SOLICITATION ADDENDUM NO. 2

Project Title	Date Prepared	Project No.
SJCCD Maritime Expansion Fire Training Center	December 4, 2019	CSP 20-12

ADDENDUM NO. 02

Project: **Maritime Expansion Fire Training Center**
 San Jacinto Community College District

C9.00
 EXISTING FIRE APPARATUS ACCESS LANE PLAN

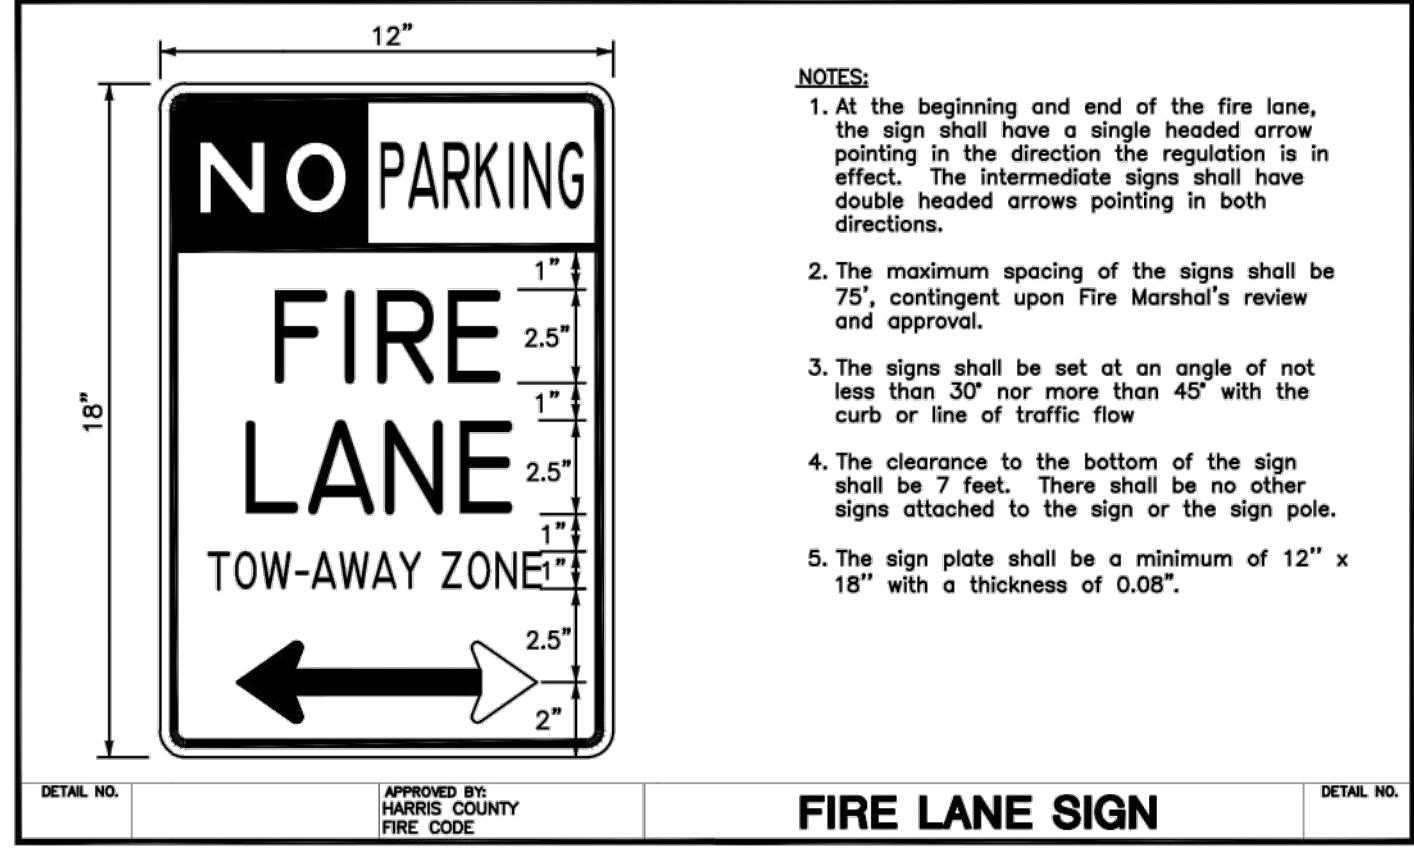
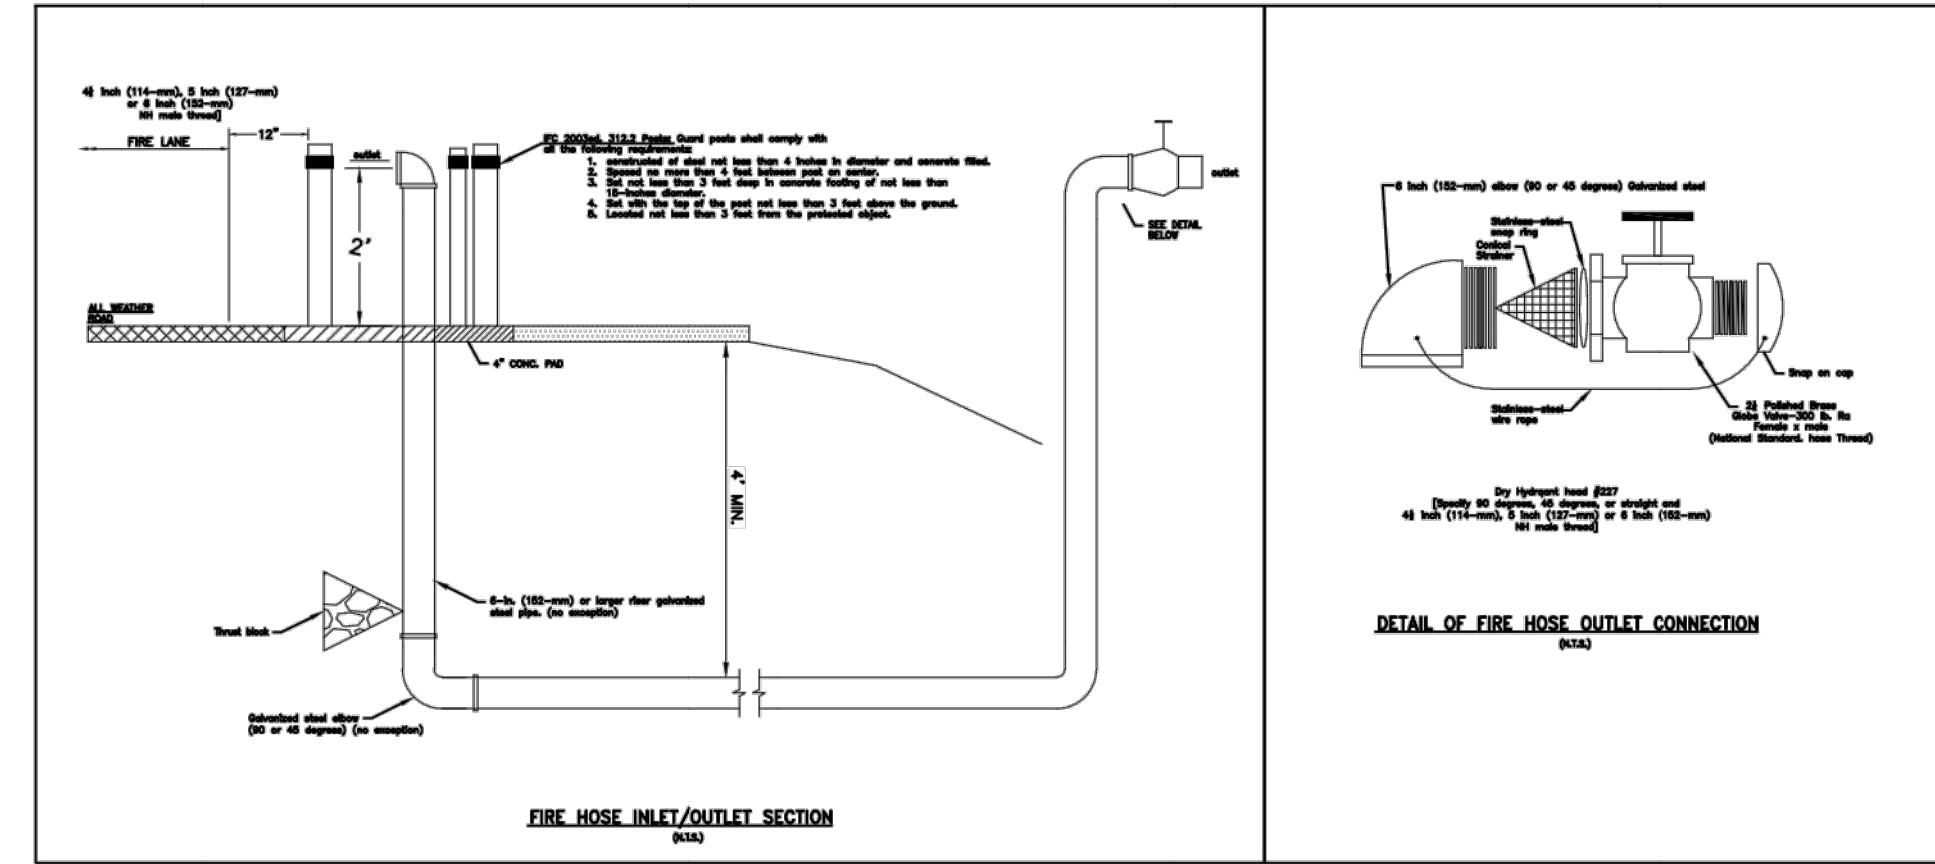
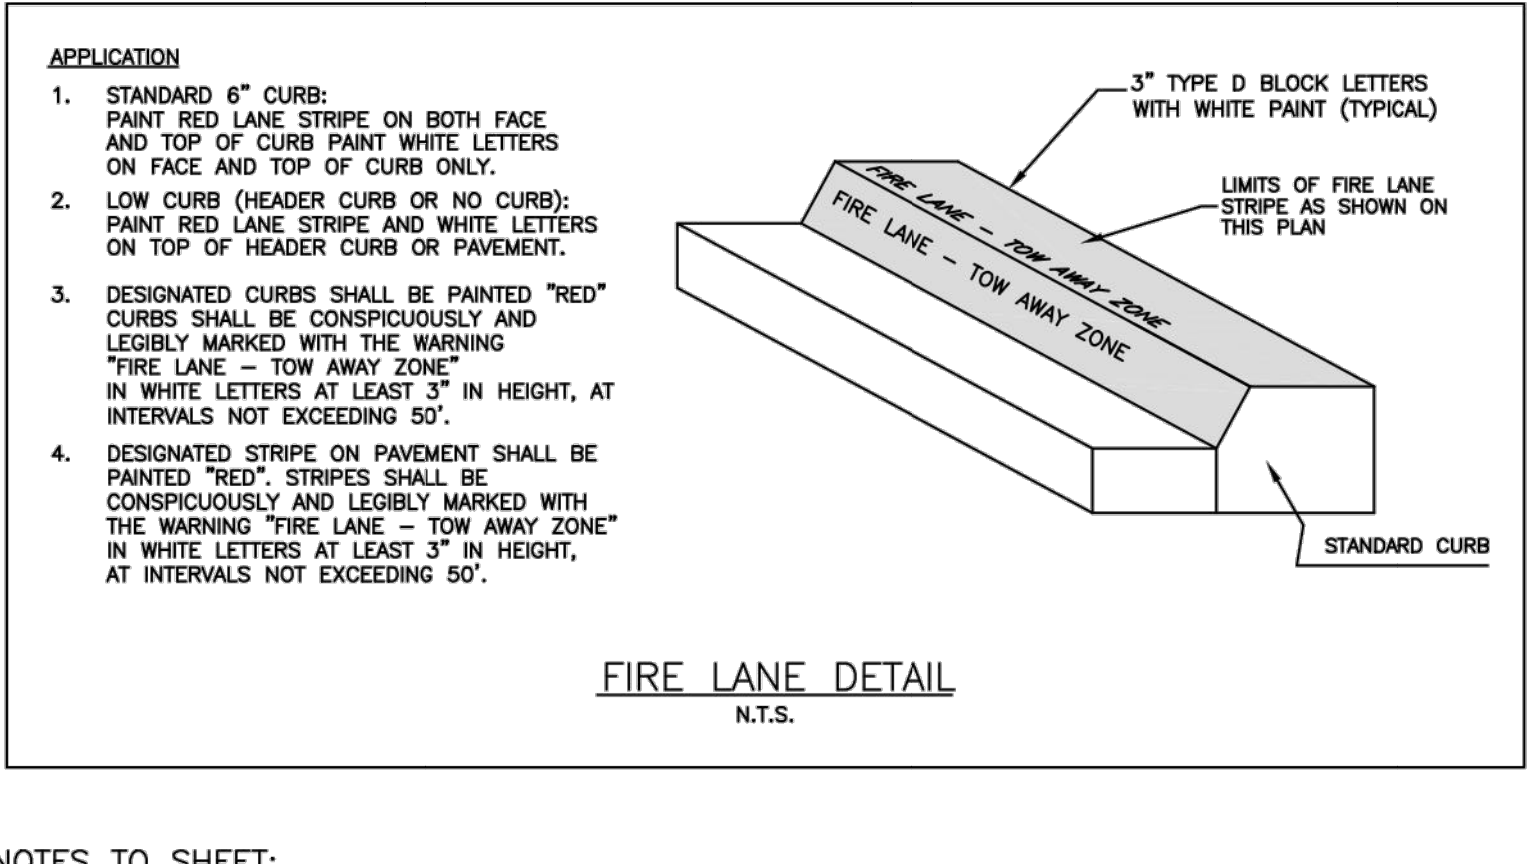
18. Sheet C9.00 – Existing Fire Apparatus Access Lane Plan
 - a. “FOR REFERENCE ONLY” placed over the existing sheet. Maritime Center project included the Fire Apparatus Access Lane Plan necessary for Harris County Fire Coder permitting reasons and to identify that there already is a Fire Access Lane previously installed and permitted by Harris County.
